Access Report

Homes NSW – Tweed Heads
25-27 Boyd Street
Tweed Heads NSW 2485

For: CKDS
Ref: PAA_22478

Development application documentation for the proposed Homes NSW – Tweed Heads project, located at 25-27 Boyd Street, Tweed Heads, has been reviewed against current accessibility legislation.

Figure 2 | Site Plan

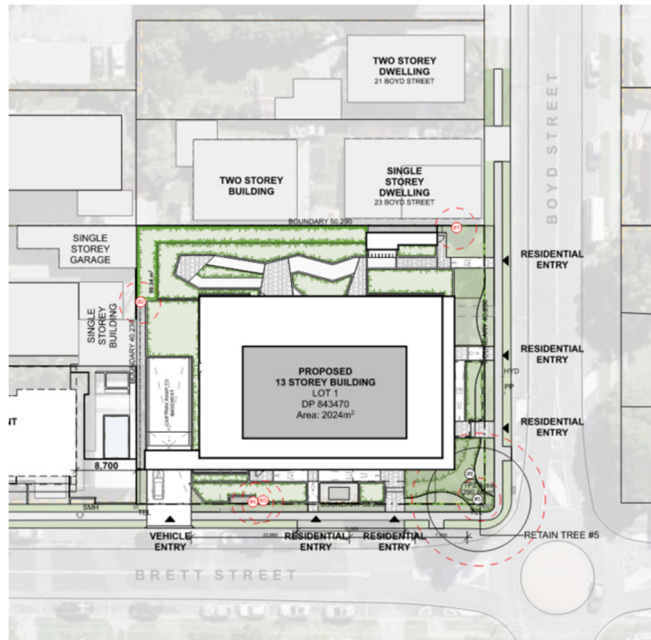
An accessible path of travel is provided to the building entrance from the allotment boundary along Boyd Street and Brett Street via formed footpaths and 1:20 walkways. On-grade access is achievable.

Pathways that form the approach to the building are of varying widths and are at least 1000mm wide meeting AS1428.1 requirement. Continuous accessible path of travel to the building entrance is achievable.

Stairs are provided as a part of the pedestrian access from both Boyd Street and Brett Street to the building entrance. The overall configuration of the stairs achieves compliance with current legislation including handrails both sides and tactile indicators top and bottom.

We note stairs are setback at least 900mm from the allotment boundary to allow for handrail extensions and TGSI. Ensure provision of contrasting non-slip nosing to treads during CC.

Two (2) 1:20 walkways are provided, fronting Boyd Street and Brett Street and offer accessible paths of travel to the building.
